TO: DISTRIBUTION
FROM: C NEUMEYER
SUBJECT: NSTX VOLTAGE ISOLATION

The purpose of this memo is to revisit the requirements for voltage isolation and segregation of components associated with the center stack casing and outer vacuum vessel, and to recommend revisions to the requirements and other changes based on operating experience gained thus far.

Figure 2

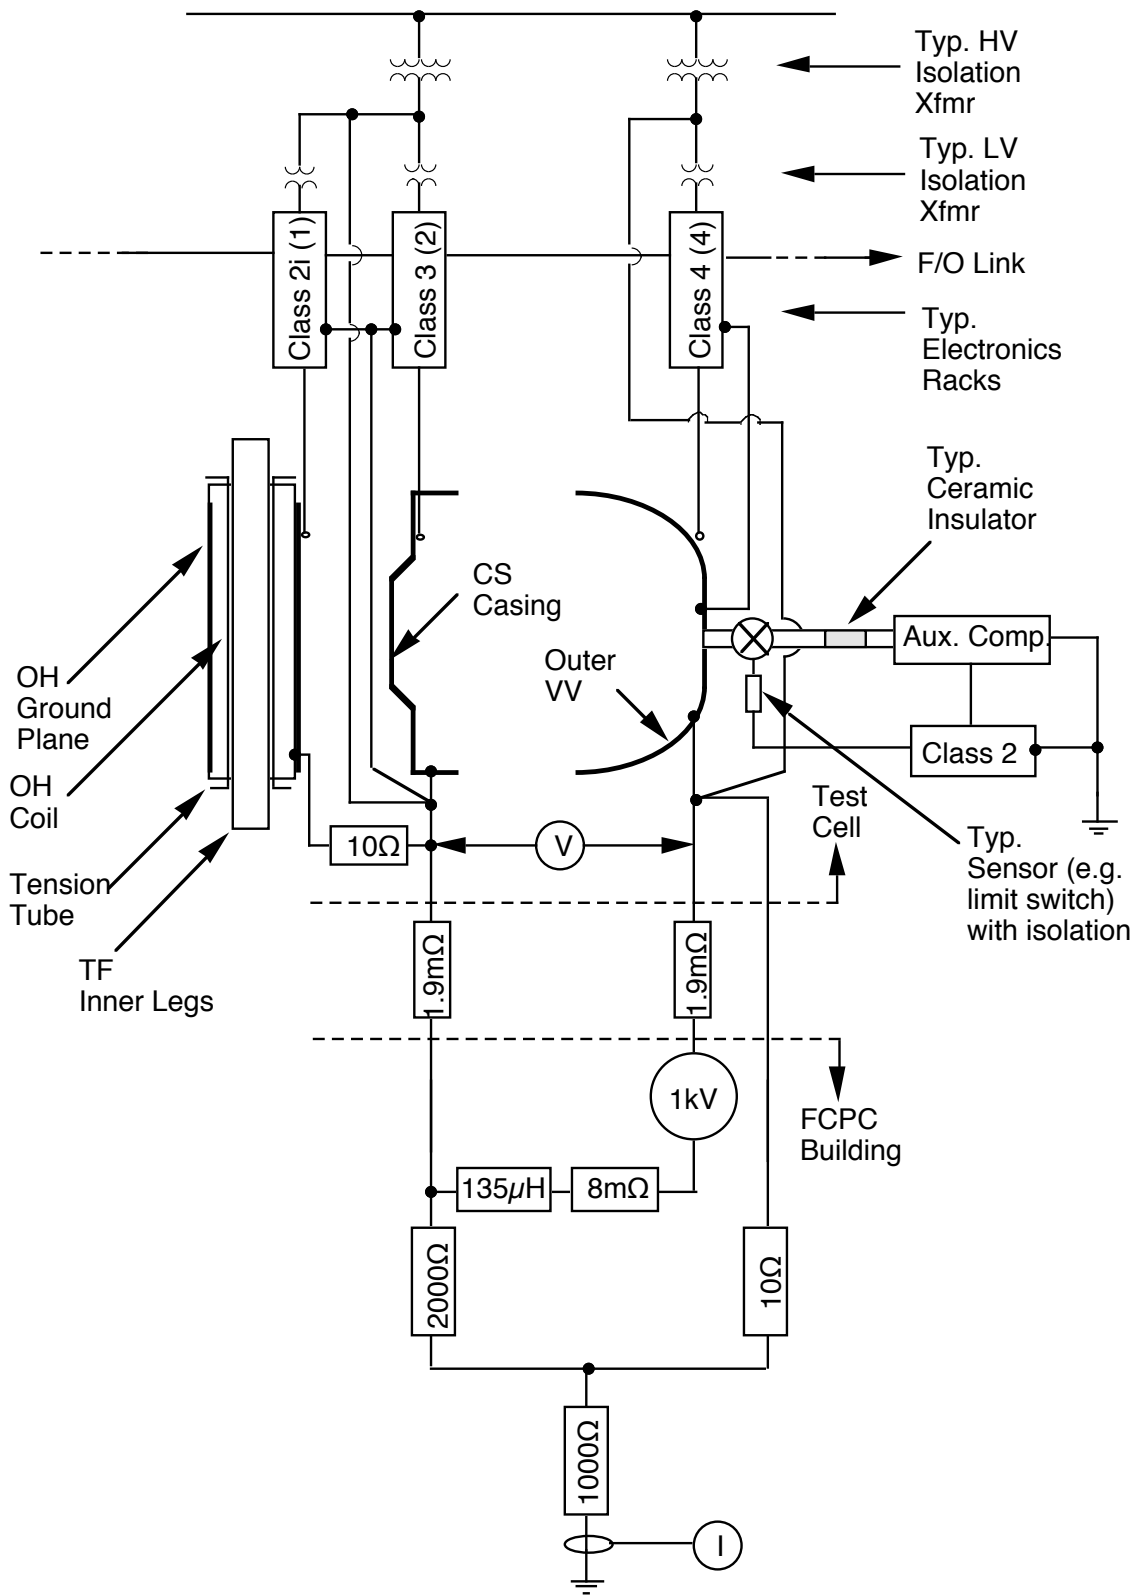
The present situation is depicted in Figure 2 and is described as follows:

- The OH ground plane, which extends only around the outside of the OH coil, is connected to the CSC through 10Ω (this is shown for simplicity only on the bottom of the machine; in fact the ground plane is divided into upper and lower parts, each further divided into two parts toroidally. Each of these four parts connects to the CSC through 10Ω . The connections are made locally on the top and bottom of the machine to avoid excess loop inductance.

- The tension tube within the OH coil, and surrounding the TF coil inner legs, has at present, no fixed voltage reference.
- Class 4 diagnostics are those which are physically mounted on, and in some cases electrically connected to, the outer VV or internal hardware mounted to same. They go to dedicated electronics racks, and feed into high input impedance differential amplifiers. The common of the Class 4 racks are tied to the outer VV via a single cable. The Class 4 racks have a dedicated 120VAC feed through a high voltage isolation transformer as well as a low voltage (Topaz type) isolation transformers at each rack. The load side of the high voltage isolation transformer connects to the outer VV via a single cable at the CHI bus. There are four Class 4 racks at present.

Because of the concern about breakdown in the annular region between the CSC and the OH coil ground plane, the scheme which ties the CSC potential to the OH ground plane (through the 10 Ω resistors) remains the preferred one.

The OH Tension Tube, PF1A and PF1B coil holders and ground planes, and the TF Hub Assemblies are all tied together due to their mechanical contact. However, at present there is no direct connection to any reference. But, the PF1A coils groundwalls do have thermocouples attached which go to the Class 2i rack.

It is recommended that a local 10 Ω connection be put in place between the aforementioned group of items and the CSC, both top and bottom (even though the tension tube bridges between the top and bottom, for transients, the connection both above and below is preferred).

- *Future CHI operations shall be limited to 1kV;*
- *The now floating group of components(OH tension tube, PF1a and PF1b ground planes and coil holders, TF hub assemblies) shall be tied locally to the center stack casing on top and bottom using 10 Ω resistors;*
